Town and Country Planning Act 1990  
Planning and Compulsory Purchase Act 2004  
Appeal by Catesby Strategic Land Ltd

***Land at Moat Road, Headcorn***

Rebuttal Proof of Evidence on Transport and Accessibility

PINS Ref: APP/U2235/W/24/3351435

Drawing 20472-05a

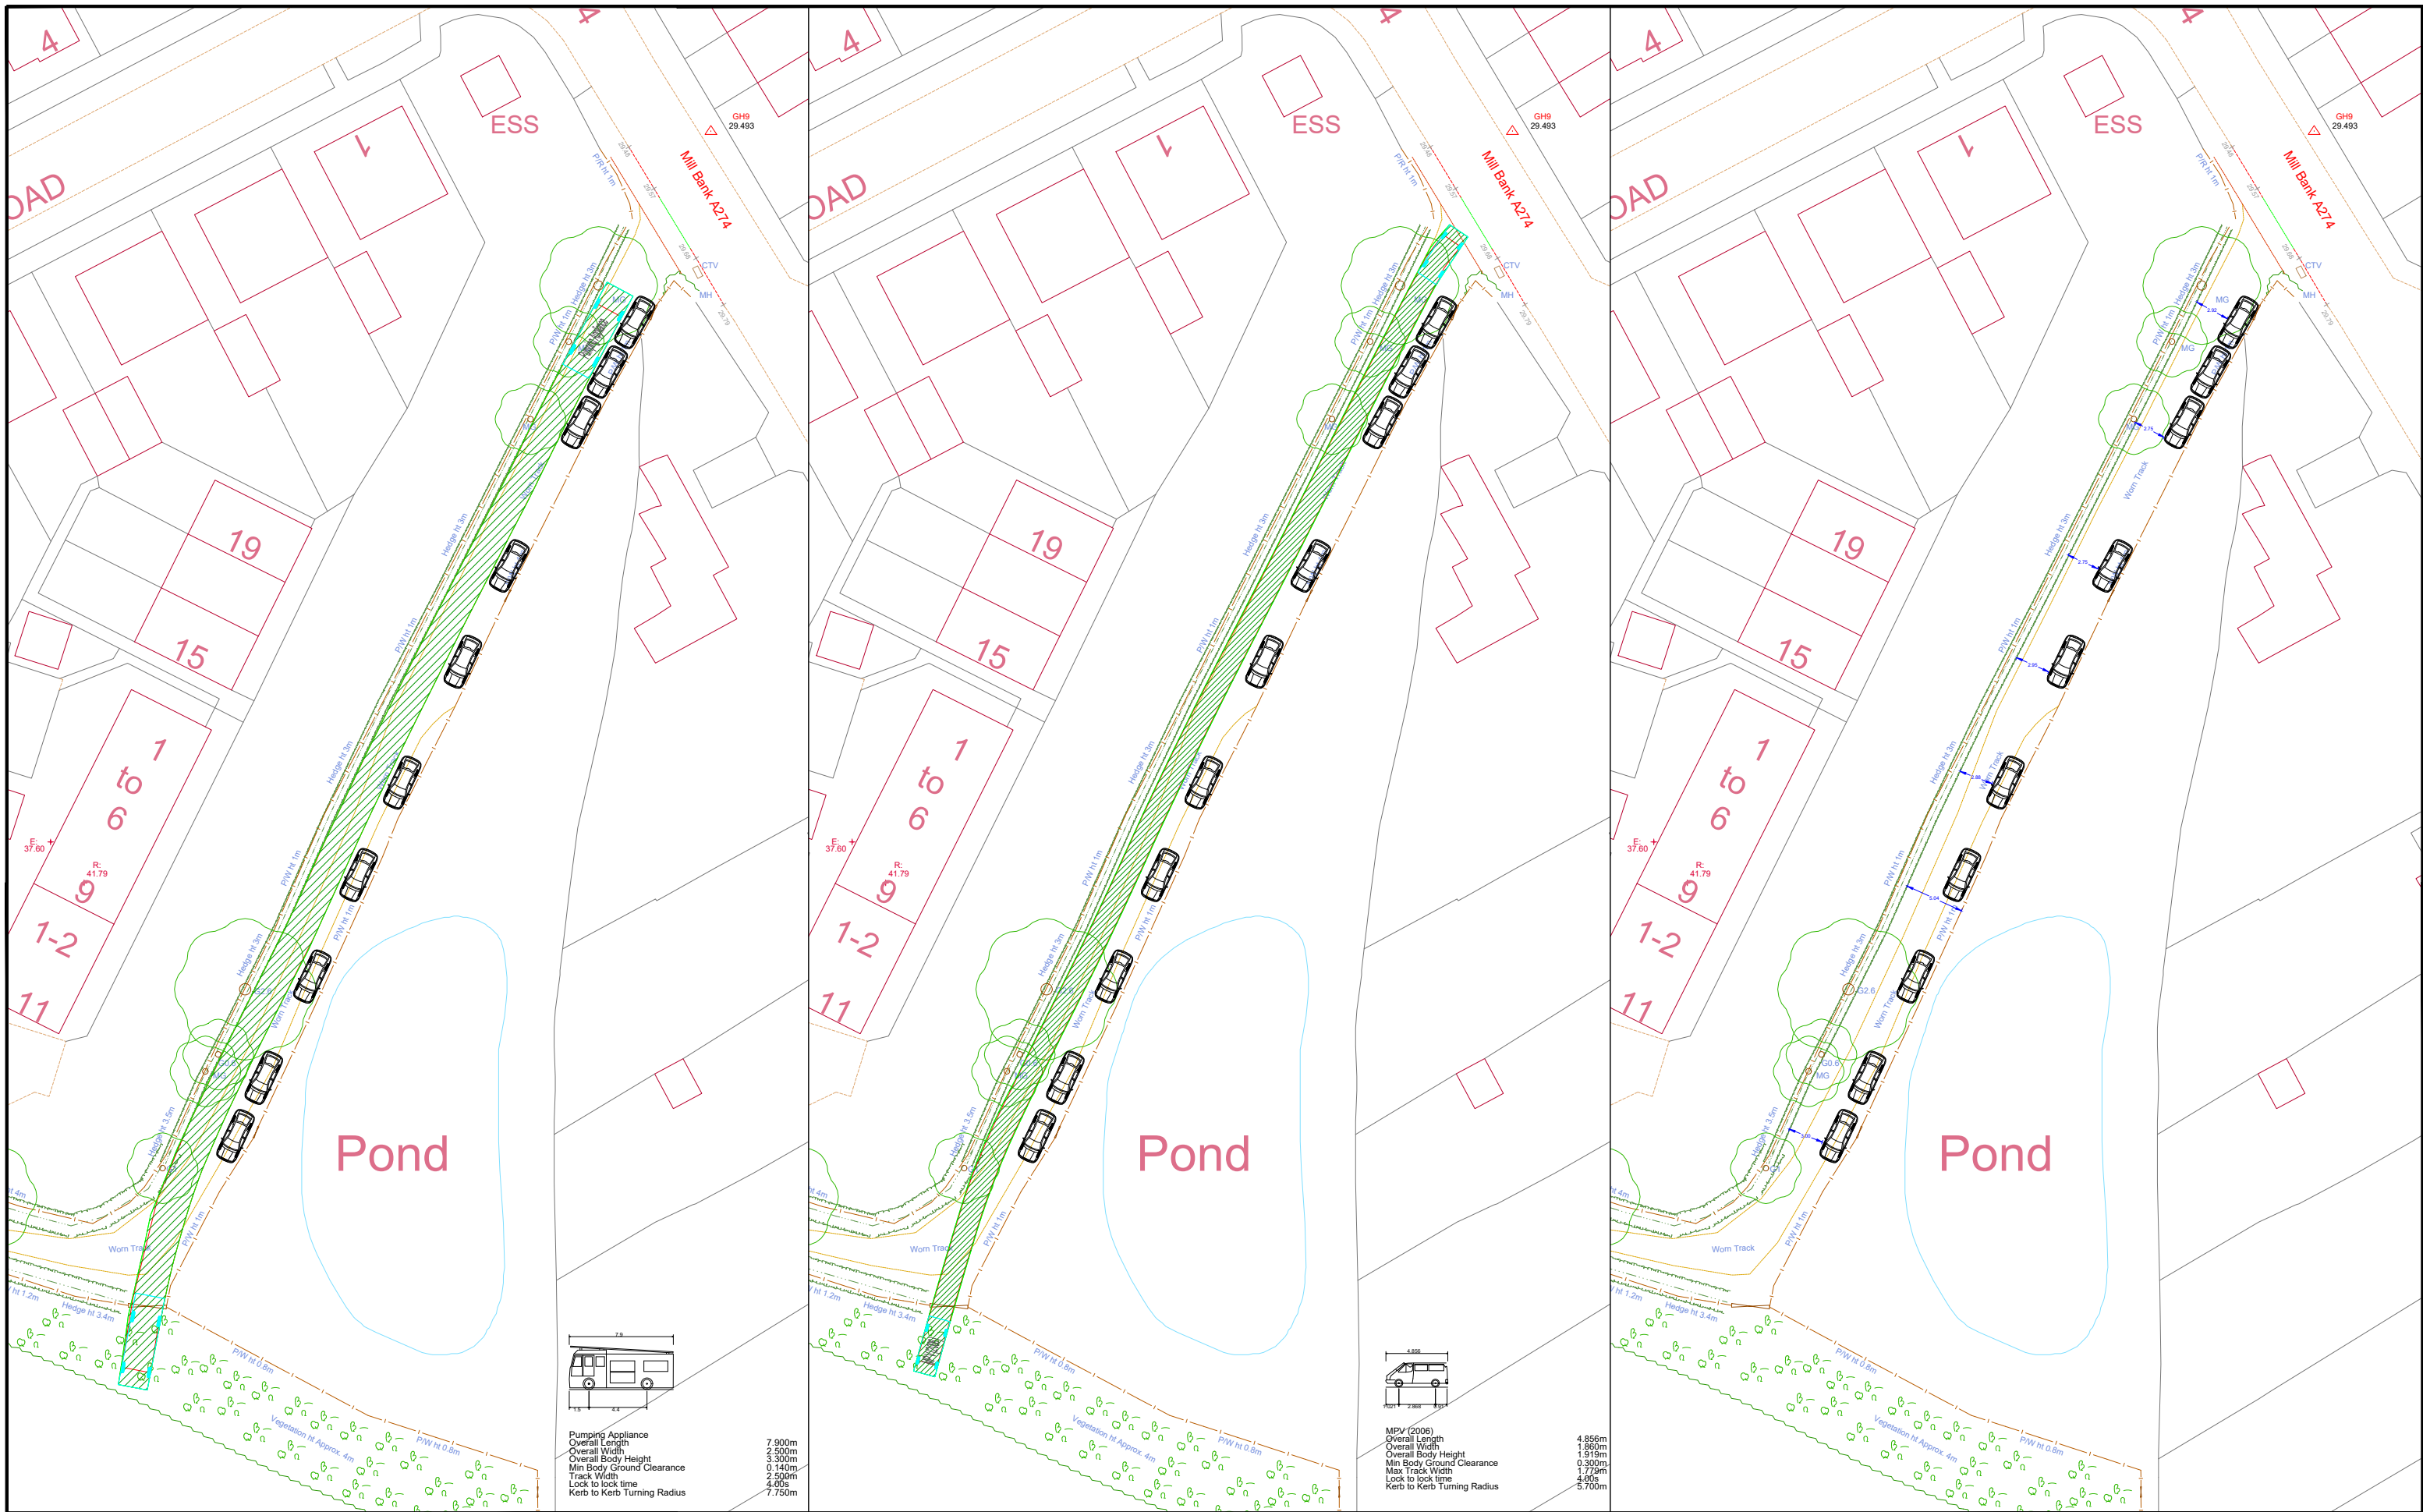
*4.15 With a maximum width of 4.3m and a minimum width of 2.1m, it is clear that an emergency vehicle, or other service vehicle, could not pass a moving or parked car along the track.*

*4.18 Manual for Streets (paragraph 6.7.3) similarly confirms that a 3.7m width is required for the fire service to operate, although simply to reach a fire, a 2.75m width over a short distance can be acceptable.*

*4.19 From the above, it is clear to see that the right of way does not meet the width requirements for an emergency access, in the event that the main access to Moat Road is blocked by a flood, or any other event.*

2.2.4 Drawing 20472-05 appended to CD1.35 and provided as Appendix DN2 of my proof provides the measured topographical survey of the northern access. This shows a minimum width of c4.66m not 2.1m which is referred to in CD1.35 as the current “used” width of the track.

2.2.5 Drawing 20472-05a is attached to this rebuttal as **Appendix DNR1**. This is to provide the Inquiry with clarification regarding the actual width of the route and the ability for a fire tender to pass a parked vehicle. For the avoidance of doubt, the access track is *private* land and there is no right to park on it. There is, nonetheless, room to pass any parked vehicle(s).

2.2.6 The drawing shows that a width of 2.75m would be available between a parked car and the opposite hedgerow at the narrowest point of the lane. Therefore, should (in the 1:100 flood event with CC allowance) a car be parked on the route at the time that an emergency vehicle requires access to the site because access via Moat Road is not available, then there would be sufficient room for it to pass.
